**SUBJECT: PALO VERDE NUCLEAR GENERATING STATION, UNITS 1, 2, AND 3 -
STAFF ASSESSMENT OF INFORMATION PROVIDED UNDER TITLE 10 OF
THE *CODE OF FEDERAL REGULATIONS* PART 50, SECTION 50.54(f),
SEISMIC HAZARD REEVALUATIONS FOR RECOMMENDATION 2.1 OF THE
NEAR-TERM TASK FORCE REVIEW OF INSIGHTS FROM THE FUKUSHIMA
DAI-ICHI ACCIDENT AND STAFF CLOSURE OF ACTIVITIES ASSOCIATED
WITH RECOMMENDATION 2.1, "SEISMIC" (CAC NOS. MF5277, MF5278 AND
MF5279)**

STAFF ASSESSMENT BY THE OFFICE OF NUCLEAR REACTOR REGULATION

RELATED TO SEISMIC HAZARD AND SCREENING REPORT

PALO VERDE NUCLEAR GENERATING STATION, UNITS 1, 2, AND 3

Figure 3.4.3-1. Comparison of PVNGS V_S-kappa factors from the licensee (dotted lines) and NRC staff's confirmatory analyses (solid lines).

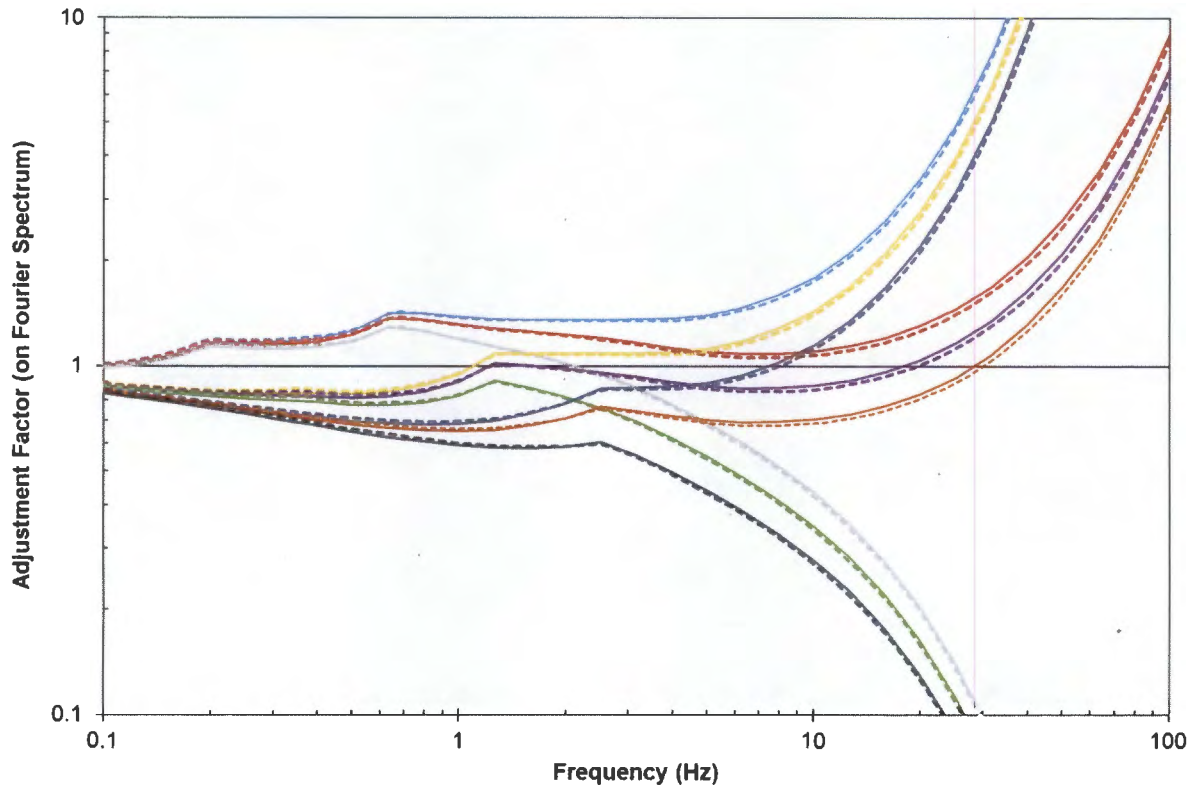
To review the input spectra used by the licensee for its site response analysis, the staff performed confirmatory calculations to evaluate the licensee's set of 9 V_S -kappa conversion factors. The method used by the staff to develop confirmatory V_S -kappa conversion factors involves calculating the impedance contrast between the host and target V_S profiles, as well as adjusting the high-frequency decay of the input spectra to account for the difference between the host and target kappa values. Figure 3.4.3-1 of this staff assessment shows that the staff's V_S -kappa conversion factors (solid lines) closely match the licensee's conversion factors (dotted lines). Based on this result, the staff concludes that the licensee adequately took into account the necessary conversion of the host WUS generic ground motions to the target site-specific conditions.

Figure 3.4.5-1. Comparison of the median and natural log standard deviation for amplification functions derived by the NRC staff and by the licensee, for the base case velocity profile at 1, 5, and 10 Hz spectral frequencies.

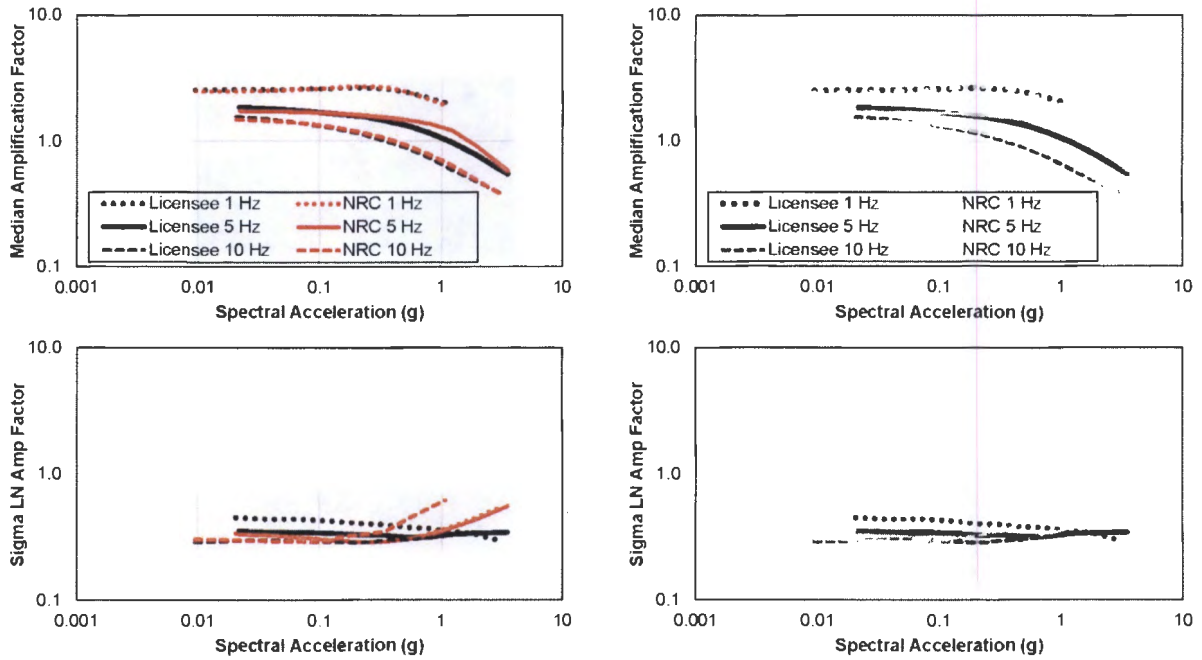
Figure 3.4.5-1 of this assessment shows a comparison of the median and natural log standard deviation for amplification functions derived by the NRC staff and by the licensee, for the base case velocity profile at 1, 5 and 10 Hz spectral frequencies. As shown in Figure 3.4.5-1, the staff and licensee's site response evaluations resulted in similar median amplification factors and associated uncertainties across the range of input spectral accelerations.

Figure 3.5.1-1. Ground Motion Response Spectrum (GMRS) and Design Spectral Response Curve (DSRC) from SHSR (Cadogan, 2015a). Safe Shutdown Earthquake (SSE) from UFSAR (APS, 2013).

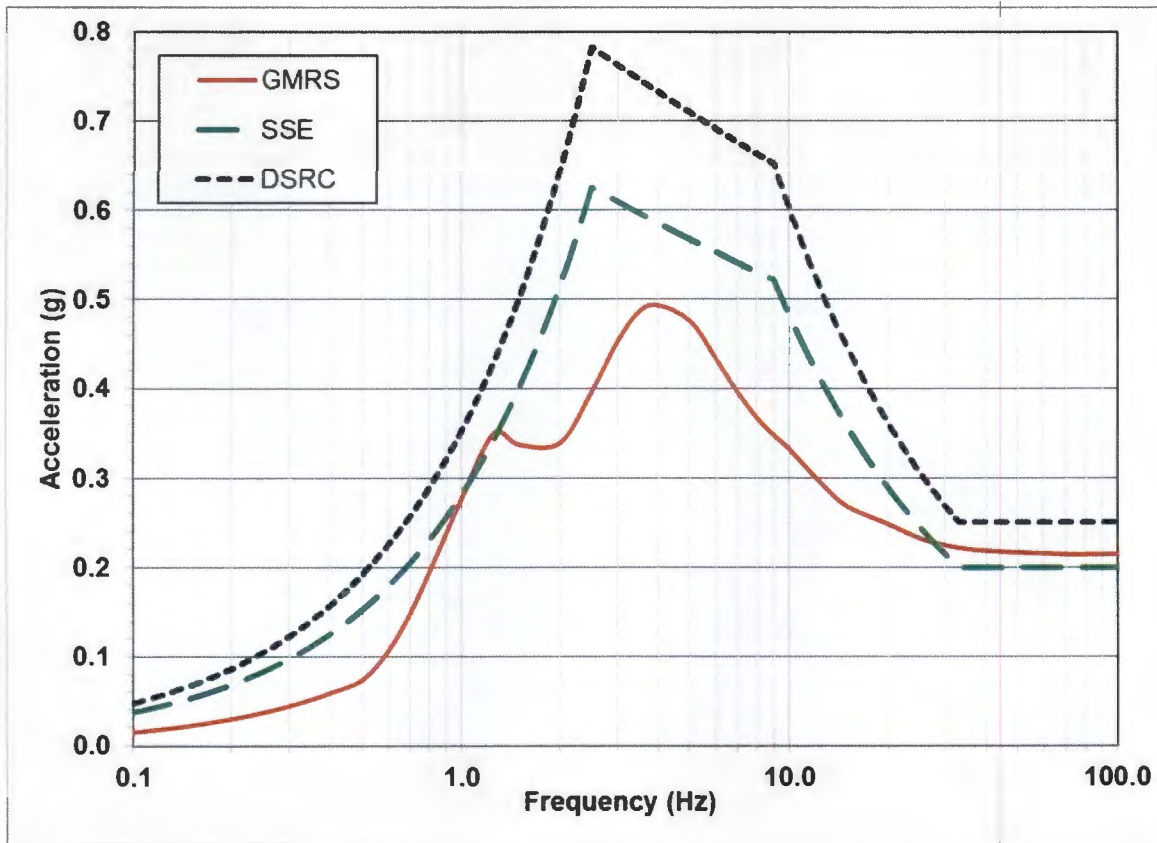
The GMRS is used to represent the free-field seismic hazard at the top of the soil column. To calculate the GMRS, the licensee first used site-specific rock hazard curves from the PSHA (reviewed in Section 3.3) and the soil amplification functions (reviewed in Section 3.4) to calculate control point hazard curves. The licensee then used these curves to develop uniform hazard response spectra at 10^{-4} and 10^{-5} mean annual frequencies of exceedance, and then computed the GMRS using the criteria in RG 1.208 (NRC, 2007). The resulting horizontal GMRS for the PVNGS site is shown in Figure 3.5.1-1 of this staff assessment.

In reaching this conclusion, the staff determined that the licensee's SHSR screening on the plant's Design Spectral Response Curve was not an acceptable basis for evaluating the plant's SSE against the GMRS, as specified in item (4) of Enclosure 1 of the 50.54(f) letter (NRC, 2012a). Compared to the SSE, the staff determined that the GMRS was approximately 2 percent higher at 1.2 Hz and approximately 10 percent higher at greater than 35 Hz (Figure 3.5.1-1). Based on criteria discussed in NRC (2015c), the staff determined that these small
